## **STAFF REPORT AND RECOMMENDATION TO THE LANDMARKS COMMISSION**

**CASE FILE:** LU 16-153002 HRM AD  
PC # 15-247619  
Pearl East Building  
**REVIEW BY:** Landmarks Commission  
**WHEN:** December 19, 2016 @ 1:30pm  
**WHERE:** 1900 SW Fourth Ave., Room 2500A  
Portland, OR 97201

The applicant requests approval of 6-story office building with a three story underground parking garage for 45 vehicles and rooftop amenity space. The proposed building includes a wooden accessibility ramp and platform on its west elevation that is made to approximate the loading docks that define the 13<sup>th</sup> Avenue Historic District. The submitted drawings show a building that is primarily clad in brick with concrete at the base. End walls facing north and east are proposed to be CMU with a banded detail and board-formed concrete defining a stair tower on the north. Because the proposal is in the NW 13<sup>th</sup> Avenue Historic District it requires historic resource review.

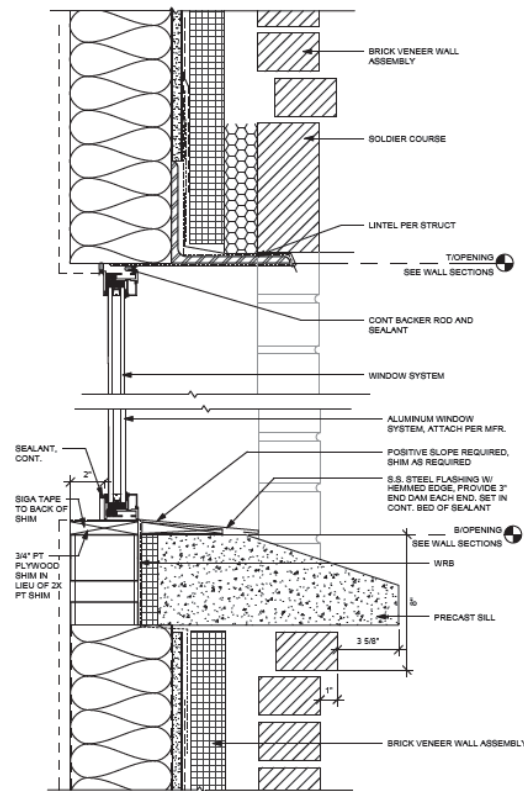
**Findings:** The code allows for 100' at this site with an option for up to 75' through bonuses and a total floor to area ratio (FAR) of 9:1. The building height is 96 feet to the top of the roof top amenity and has a total FAR of 8.16:1. The extra FAR for the project is allowed by bike rooms included in the proposal that meet the standards of 33.266.220.B which are inside the building.

Although the building is 6 stories with a penthouse the top floor has design elements that reduce its visibility through massing. This deliberate gesture will allow the building to achieve a perceived height of 6 floors. While the building will be taller than many others in the district it will be perceived at six stories in height in accordance with this guideline. The bulk of the penthouse is setback from the street facing elevations by 20' on NW 13<sup>th</sup> street and 25' at the NW Glisan Street frontage. This articulation and the buildings parapet wall will render the penthouse mostly invisible when viewed from within the right-of-way in the District. The height of the building is achieved within the constraints of the zoning code. *Therefore this guideline is met.*

3. TYPICAL WINDOW HEAD (a) AND SILL (b)  
1 1/2" = 1'-0"

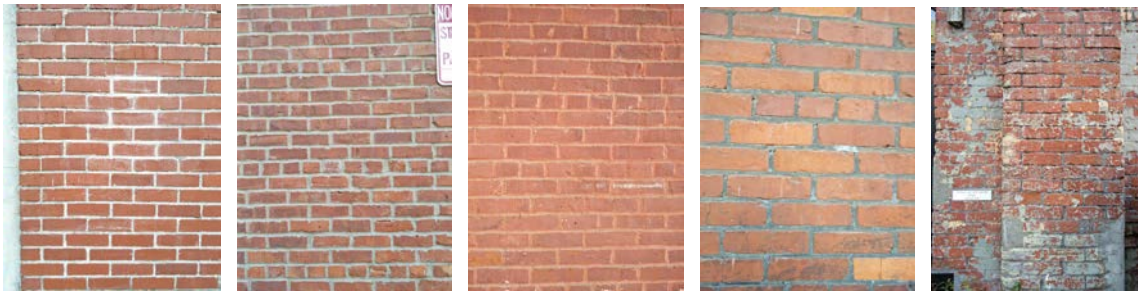
The proposal includes 6-light and 4-light aluminum windows on the upper floors with narrow mullions. The 13<sup>th</sup> Avenue ground elevation of the building includes three aluminum and glass roll up doors with a gridded muntin pattern. These are located beside three person doors. The roll up doors on the building suggest the roll up doors mentioned in Guideline 7 of the *13<sup>th</sup> Avenue Historic District Guidelines* that are commonly found in the district. Above the doors along 13<sup>th</sup> is a 4' 7 1/4" transom with two rows of square lights between aluminum muntins. The transom feature is also expressed on the Glisan Street elevation where it sits above two sets of five storefront windows that maintain a consistent datum despite the grade along this street. At the eastern corner of the NW Glisan Street façade, there is a metal panel garage door with metal louvers and the same gridded transom element above. The various windows, their proportion, and arrangement mimic the contributing resources in the district. The garage door opening on NW Glisan Street appears to be much larger than is standard in the district because of the presence of matching louvers above it that provide venting for the generator. However, the transom feature ties this opening in with the other fenestration on the ground floor and the inclusion of a canopy above the garage door mitigates the potentially out of scale opening. For these reasons the windows on the building meet this guideline.
